GATEWAY TRUCKING SITE DEVELOPMENT PLAN

GRADING AND EROSION CONTROL PLAN

GATEWAY TRUCKING SITE DEVELOPMENT PLAN
COVER SHEET

VICINITY MAP
SCALE: 1"=2000'

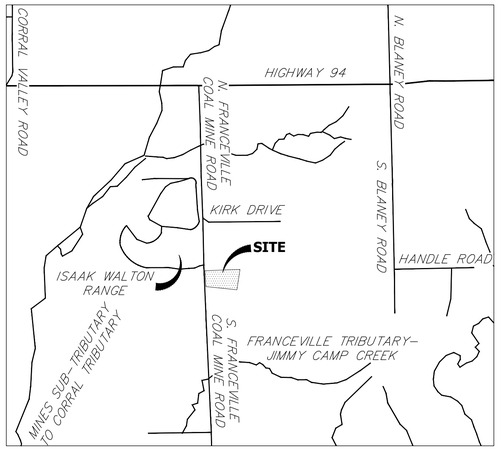
Provide an area map that shows the entire property.
- Label the property line bearing/distance and show any easements located within the property.

Created site map and added

GRADING AND EROSION CONTROL PLAN

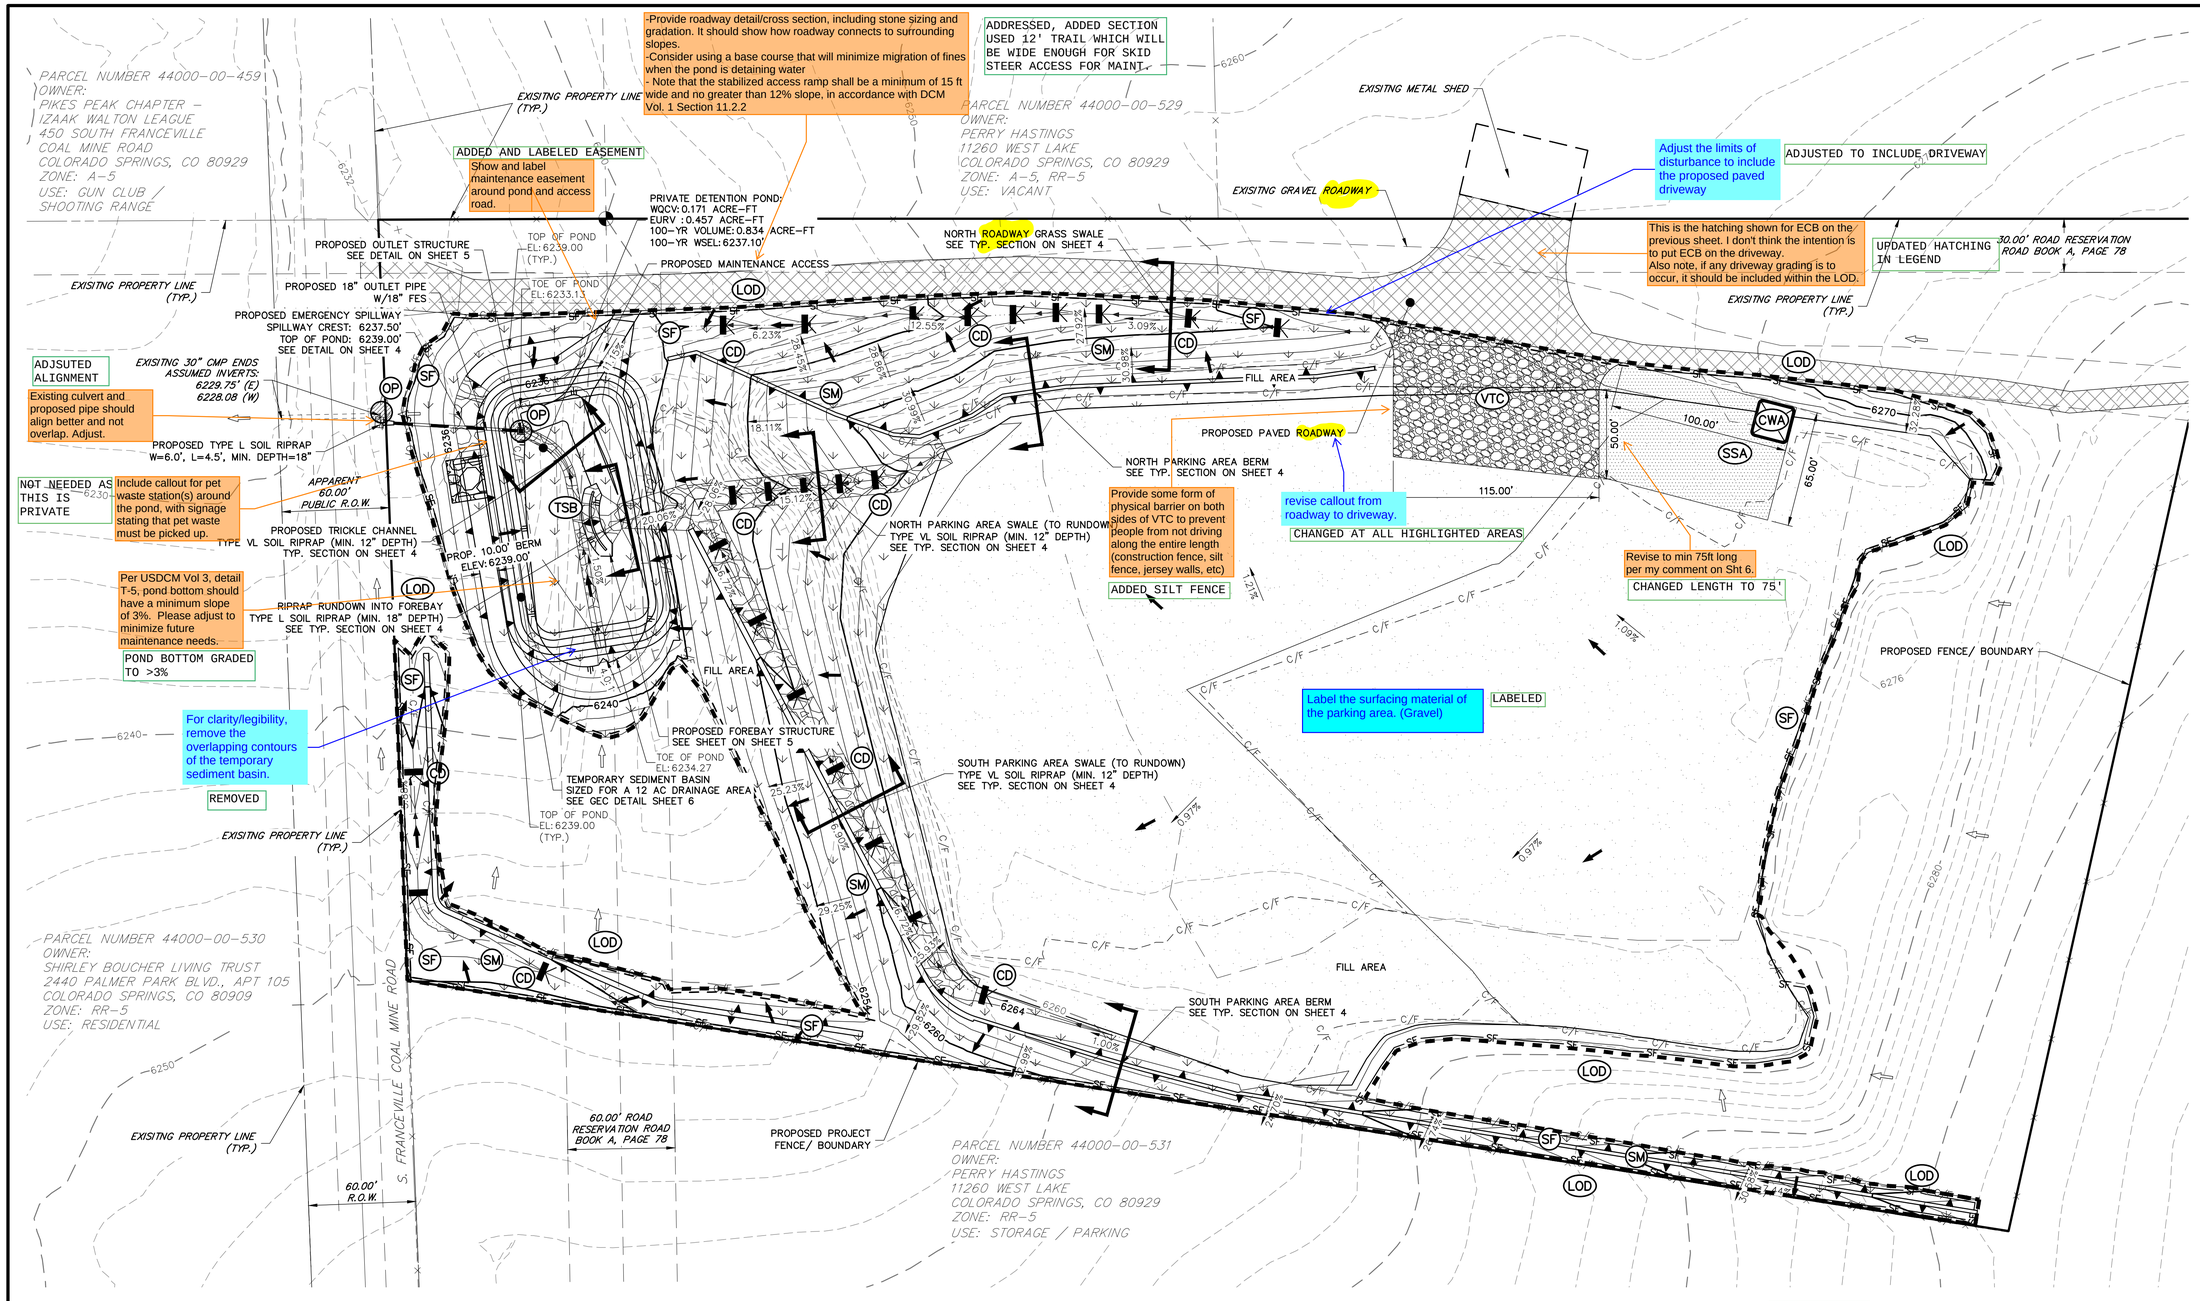
-Provide roadway detail/cross section, including stone sizing and gradation. It should show how roadway connects to surrounding slopes.
-Consider using a base course that will minimize migration of fines when the pond is detaining water
- Note that the stabilized access ramp shall be a minimum of 15 ft wide and no greater than 12% slope, in accordance with DCM Vol. 1 Section 11.2.2

Items H and M. If "limits of disturbance" and "construction boundary" are the same, change to "limits of construction/disturbance" or otherwise show as separate linetypes for each on the legend and figure.

Show location on plans.

Remove the Engineer's statement from this sheet.

Engineer's statement in the coversheet is sufficient.

ADDRESSED, ADDED SECTION USED 12' TRAIL WHICH WILL BE WIDE ENOUGH FOR SKID STEER ACCESS FOR MAINT.

CHANGED LENGEND TO INCLUDE DISTURBANCE

LOCATION IS ALREADY SHOWN ON PLANS

REMOVED BLOCK

N. ROADWAY SWALE
TYP. SECTION
SCALE: N.T.S.

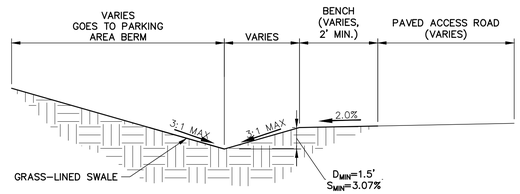
Revise to driveway

UPDATED NAME

SOIL RIPRAP EMBANKMENT PROTECTION
WITH BEDDING TYP. SECTION
N.T.S.

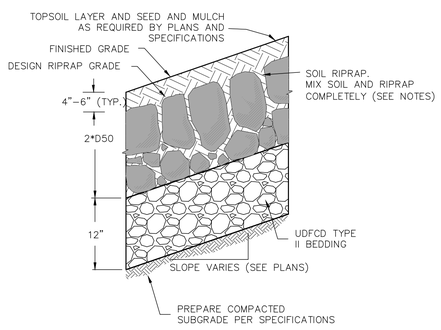
Please consider doing a concrete trickle channel instead. Soft-bottomed trickle channels cause major maintenance issues and are not recommended per the following excerpt from MHFD Detail T-5

Riprap and soil riprap lined trickle channels are not recommended due to past maintenance experiences, where the riprap was inadvertently removed along with the sediment during maintenance.

CHANGED TO CONCRETE
TRICKLE CHANNEL

POND EMERGENCY SPILLWAY
TYP. SECTION
SCALE: 1"=5'

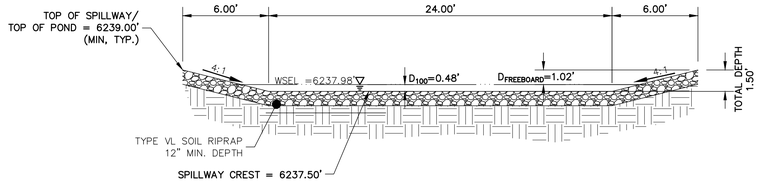
Provide the emergency spillway profile detail.

ADDED SPILLWAY PROFILE DETAIL

POND FOREBAY PLAN VIEW
SCALE: 1/8" = 1'

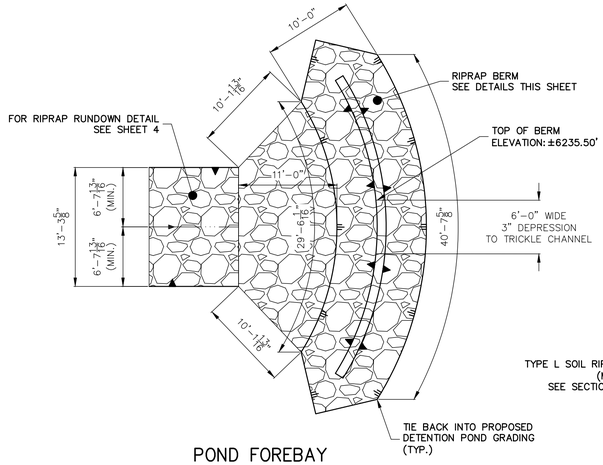
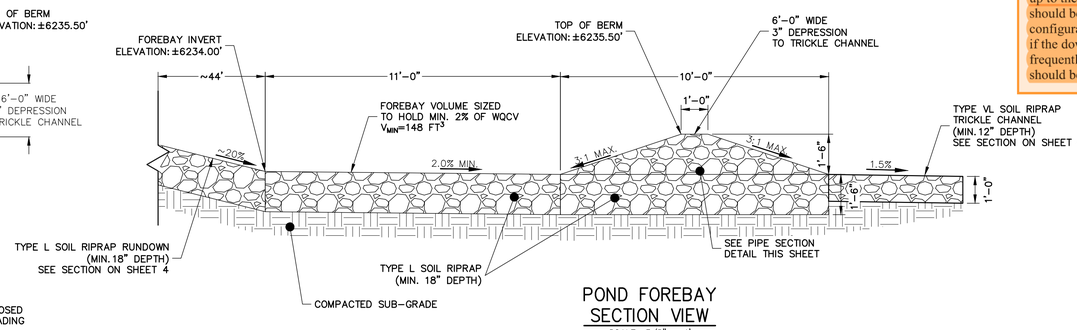
See excerpt from MHFD Detail T-5 below for recommended confirguration/design of forebay:

The forebay outlet should be sized to release 2% of the undetained peak 100-year discharge. A soil riprap berm with 3:1 sideslopes (or flatter) and a pipe outlet or a concrete wall with a notch outlet should be constructed between the forebay and the main EDB. It is recommended that the berm/pipe configuration be reserved for watersheds in excess of 20 impervious acres to accommodate the minimum recommended pipe diameter of 8 inches. When using the berm/pipe configuration, round up to the nearest standard pipe size and use a minimum diameter of 8 inches. The floor of the forebay should be concrete or lined with grouted boulders to define sediment removal limits. With either configuration, soil riprap should also be provided on the downstream side of the forebay berm or wall if the downstream grade is lower than the top of the berm or wall. The forebay will overtop frequently so this protection is necessary for erosion control. All soil riprap in the area of the forebay should be seeded and erosion control fabric should be placed to retain the seed in this high flow area.

CHANGED TO LOW TAILWATER BASIN

A A-A SECTION
SCALE: 3/8"=1'

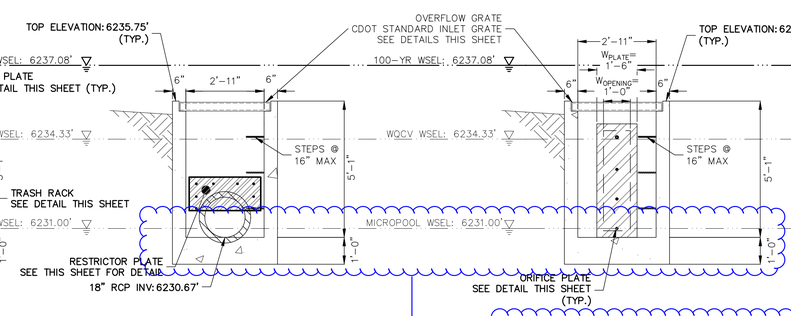
Update structure. A 2.5' deep micropool is required.

Per MHFD Detail T-12.

ADDRESSED. ADDED MICROPOOL

ORIFICE PLATE DETAIL
SCALE: 3/8"=1'

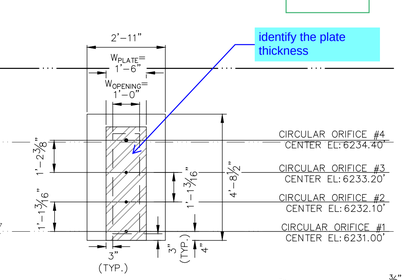
identify the plate thickness

clarify that this is for Orifice #4.

ADDRESSED

TRASH RACK AND PLATE DETAIL (PLAN)
N.T.S.

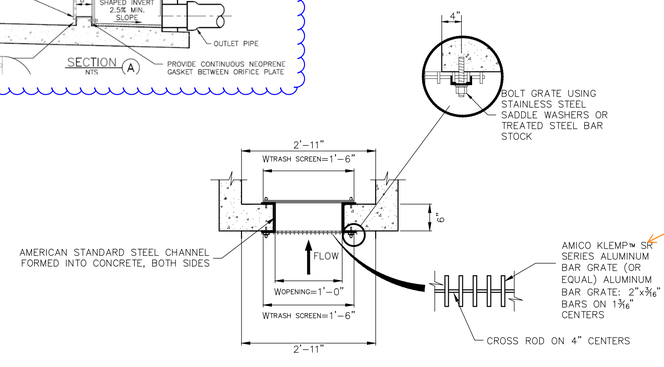
-Generally, use bar grates for orifices >1-3/16" in largest length or diameter (based on nature of min bar grate spacing). But refer to Step #9 on the EDB tab of the UD-BMP spreadsheet for when to use well screens vs bar grates (based on R-value, ie: percent open area). Note it appears the cutoff is at smallest orifice dimension of about 1-1/4".

So it seems from the above rules of thumb that a well screen may be better suited for this site. But double check with calcs and attach to FDR.

CHANGED TO WELL SCREEN TYPE TRASH RACK
